Technical Bulletin

IZIP E3 DASH AND PATH+ Rear Hub Motor

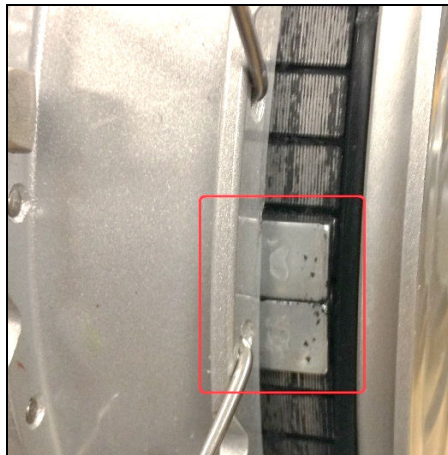
Failure Examples – Magnet(s) can come loose and adhere itself to the stator causing either clicking and/or increased resistance.

Our supplier has already made improvements to future production by using a stronger bonding agent for magnet assembly. Currie Tech is prepared to supply you with a new complete replacement wheel if you were to experience this failure. There is no need for you to disassemble the Hub Motor and prove loose magnet if you believe this issue exists on your bike, simply call in to our Customer Service Department at [1-800-377-4532](tel:1-800-377-4532)
